Portland General Electric Company

Trojan Nuclear Plant  
Docket 50-344  
License NPF-1

Response Concerning the Review of the "Risk-Based  
Inspection Guide for the Trojan Nuclear Plant" (TAC No. 72894)

PORTLAND GENERAL ELECTRIC COMPANY  
RESPONSE CONCERNING THE REVIEW OF THE "RISK-BASED  
INSPECTION GUIDE FOR THE TROJAN NUCLEAR PLANT" (TAC NO. 72894)

TROJAN NUCLEAR PLANT
REACTOR COOLANT SYSTEM
FIGURE 5.1-1 B

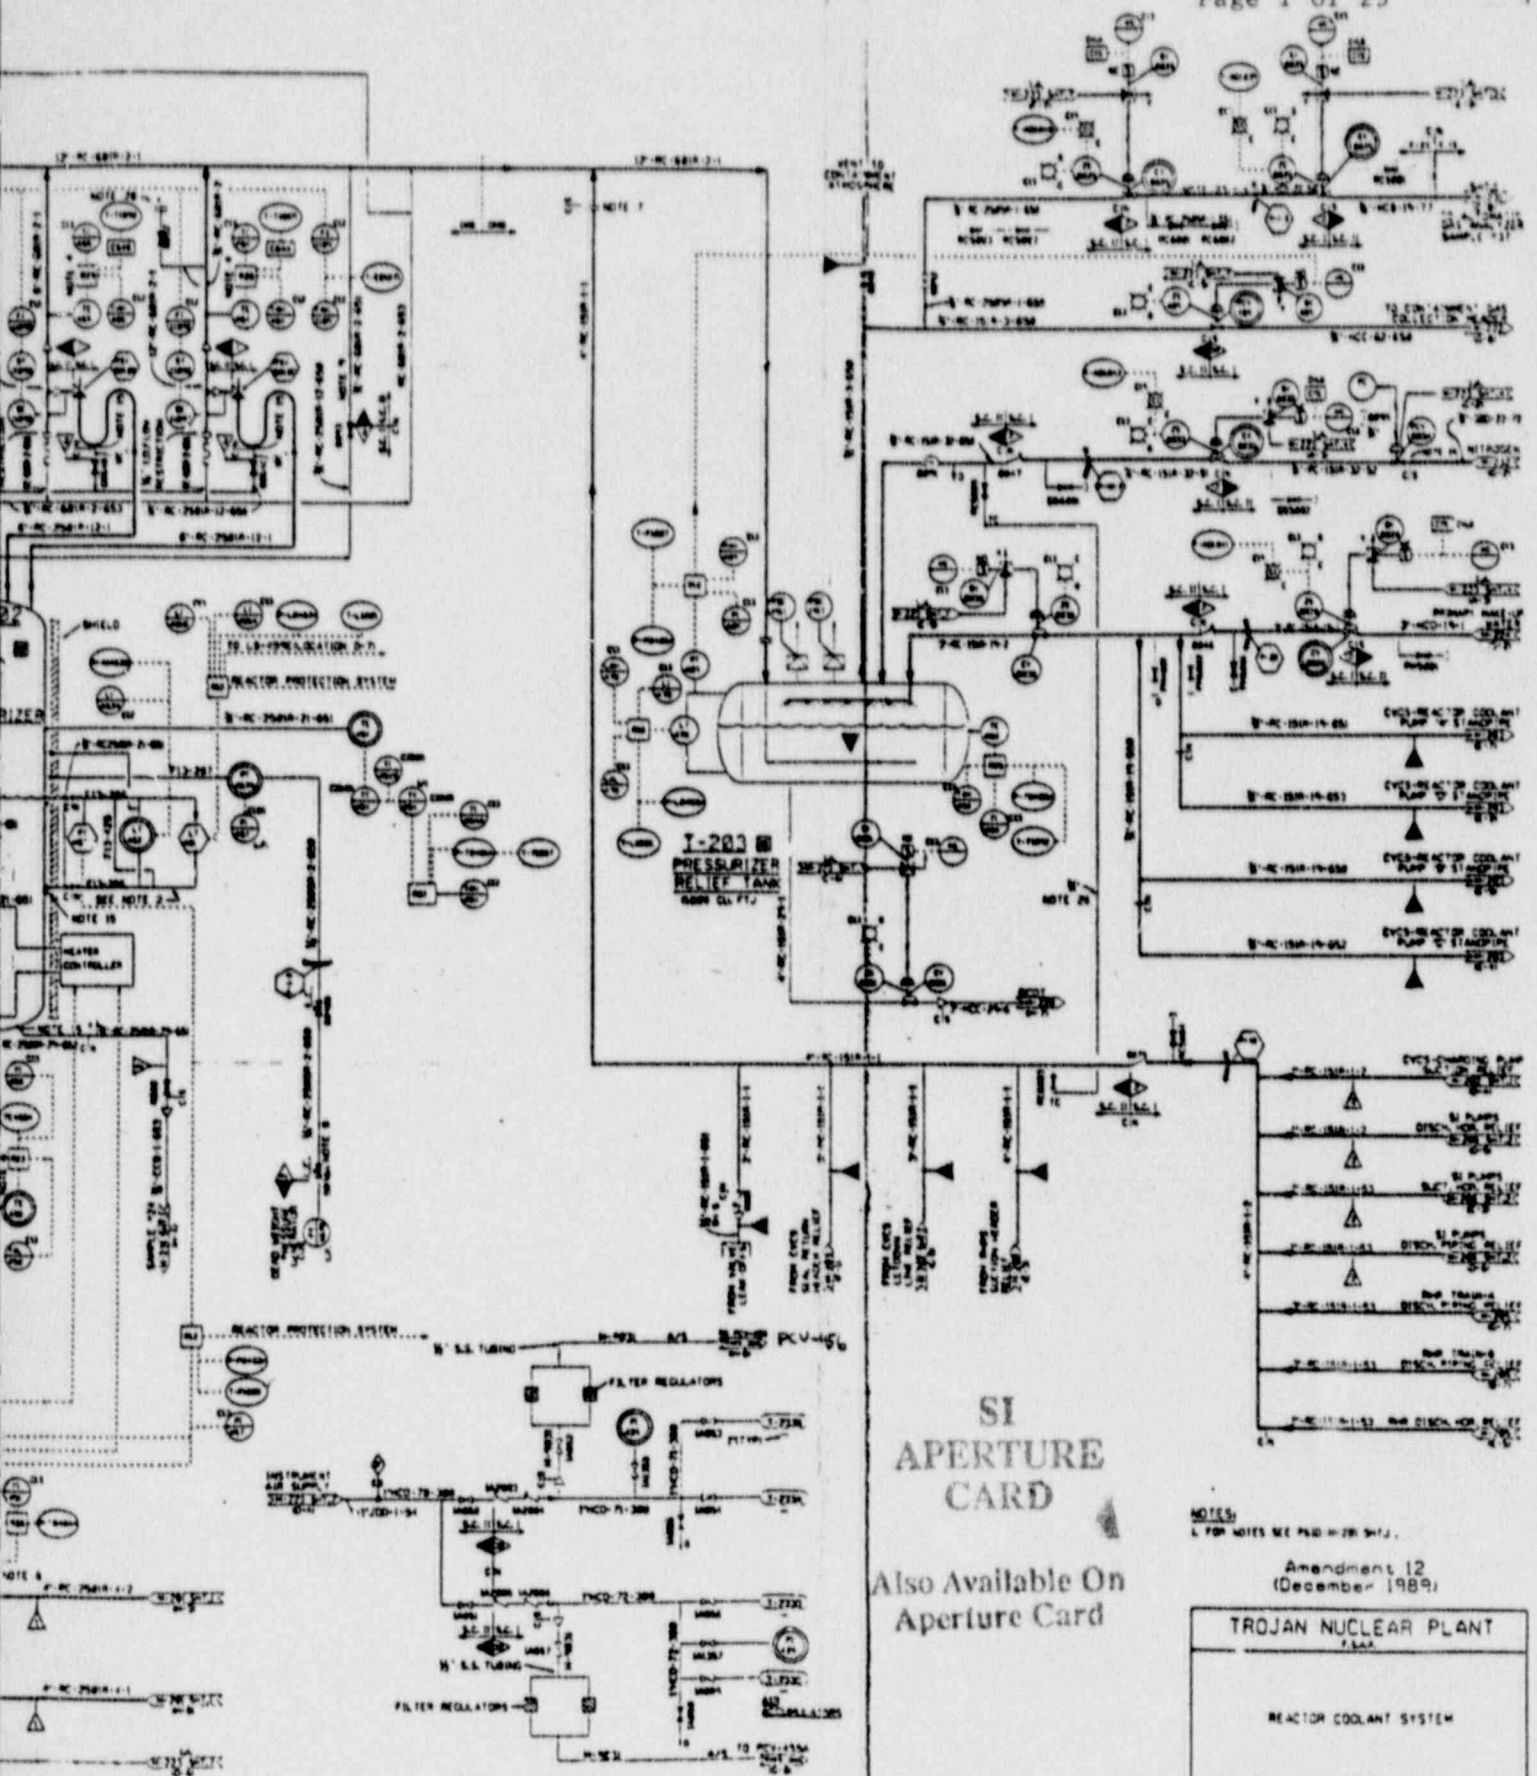
Whether the air supply to the pressurizer power-operated relief valves (PORVs) is backed by nitrogen bottles or air accumulators.

The PORVs are backed by four Seismic Category I air accumulators (T-233A, T-233B, T-233C, T-233D). These are shown on Final Safety Analysis Report (FSAR) Figure 5.1-1 B, "Reactor Coolant System", which is attached (Attachment 3).

FIGURE 3.6-22

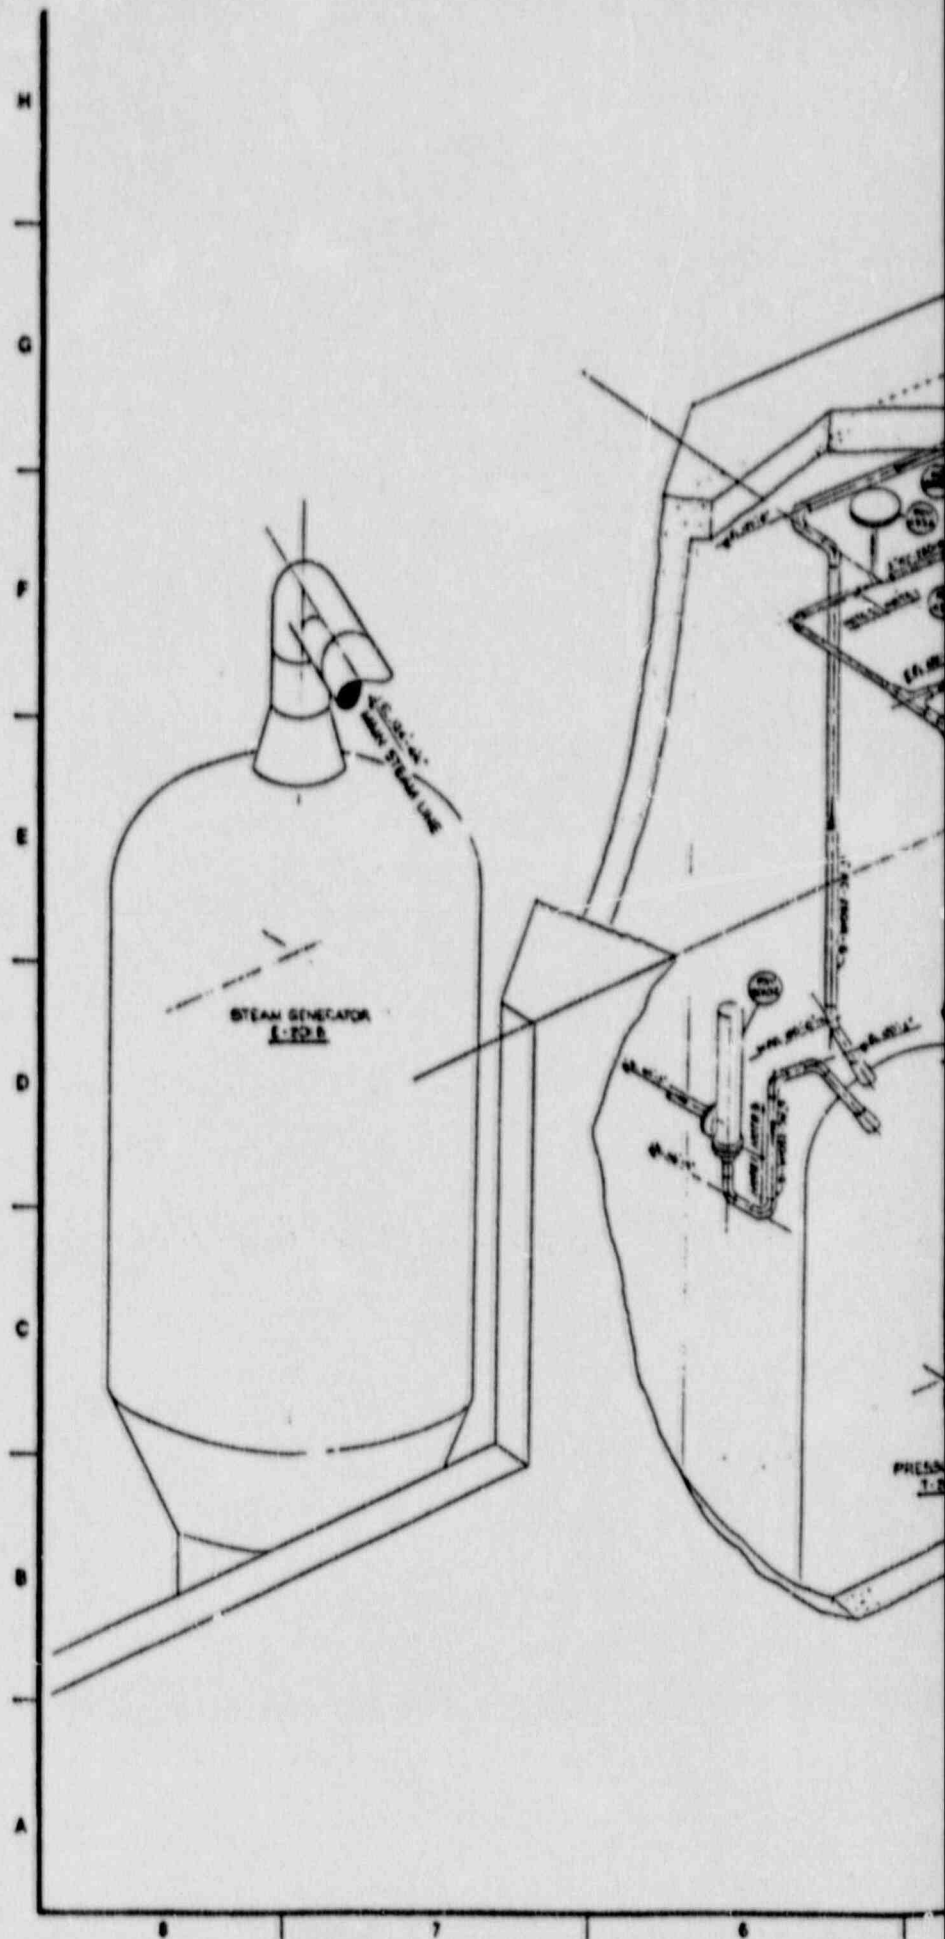
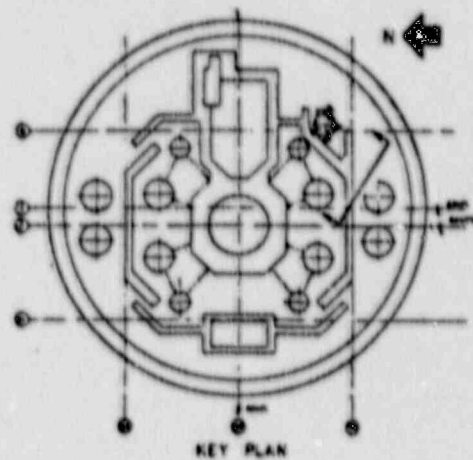
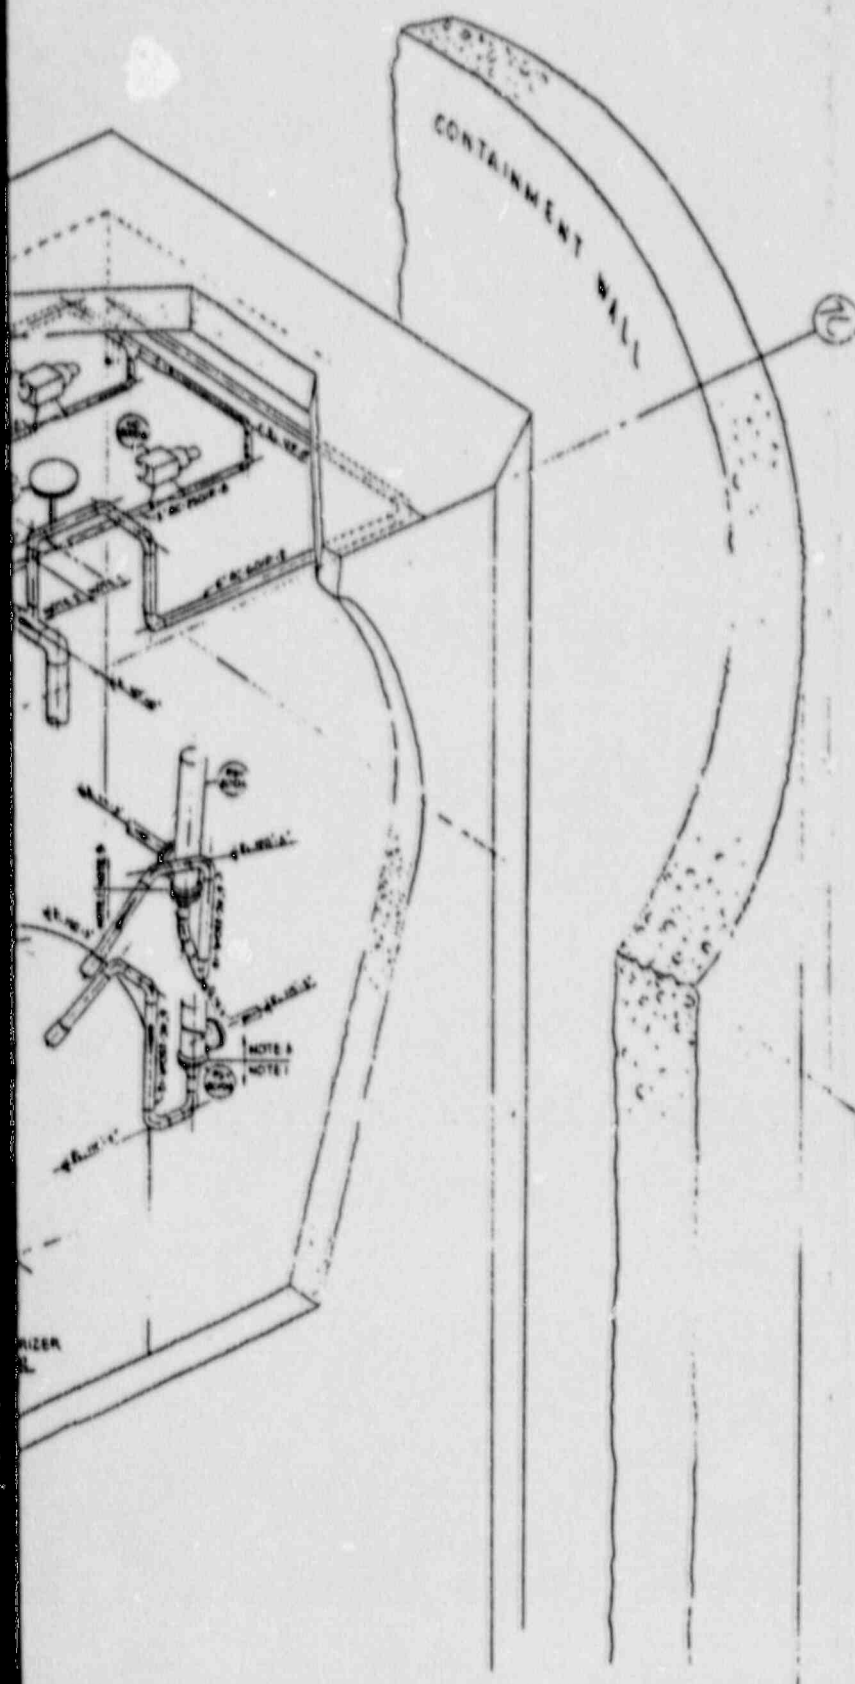
The specific locations (e.g., Containment elevations) of the SRVs, PORVs, and block valves.

These valves are shown in an isometric view in the attached (Attachment 3) FSAR Figure 3.6-22, "Pressurizer Safety and Relief Lines (RC-2501R-8 and RC-2501R-12)". The Containment elevations are as follows:

<u>SRVs</u>	<u>Elevation (MSL)*</u>
PSV-8010A	119 ft 3 inches
PSV-8010B	119 ft 3 inches
PSV-8010C	119 ft 3 inches

PCV-455A	127 ft 0 inches
PCV-456	127 ft 0 inches

MO-8000A	127 ft 0 inches
MO-8000B	127 ft 0 inches
